**Chemung County Stormwater
Construction Inspection
Erosion and Sediment Control**

Project Name Williams Toyota	Date 1-28-20
Location CR64 and Fisherville Rd. Big Flats, NY	Permit # NYR11f221
Weather Conditions cold, rainy/now	Entry Time: 8:57 am
On-Site Representative Present: NONE	Exit Time: 9:20 am

PROJECT: Williams Toyota
Town of Big Flats
Municipal Inspection
January 28, 2020

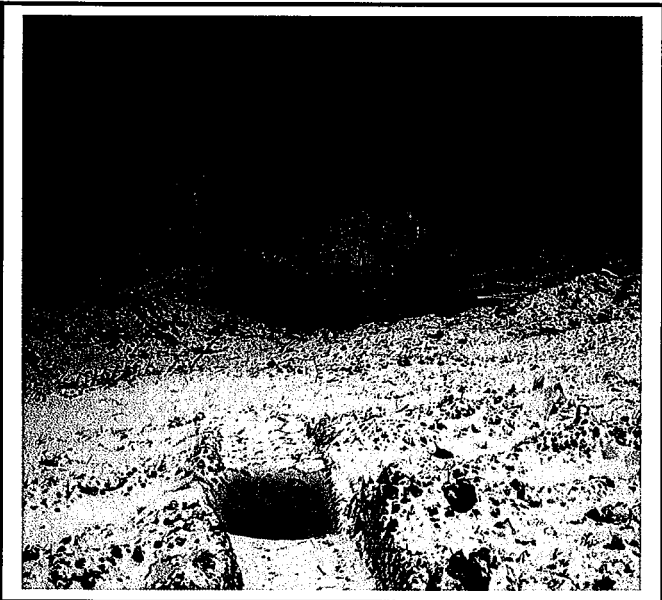
Gravel and soil have been pushed up against the silt fence.

Missing silt fence along edge of property where it is needed.

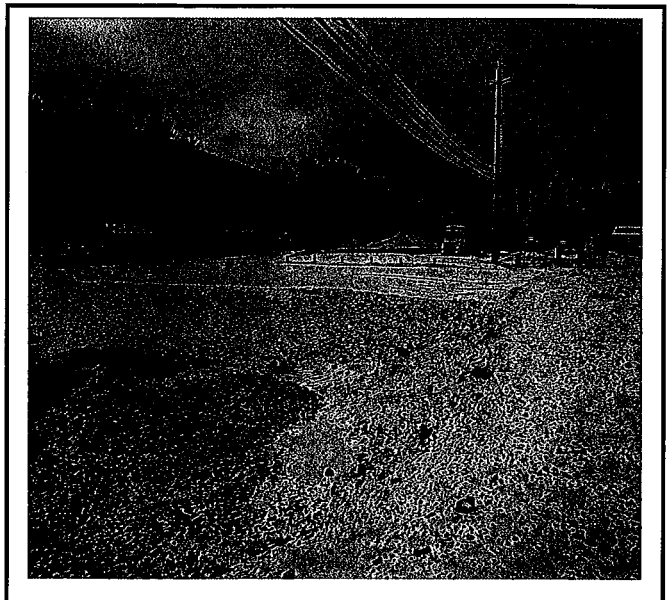
Straw bales in a concentrated flow are not an approved practice.

Underground stormwater system installed and there is not approved SWPPP.
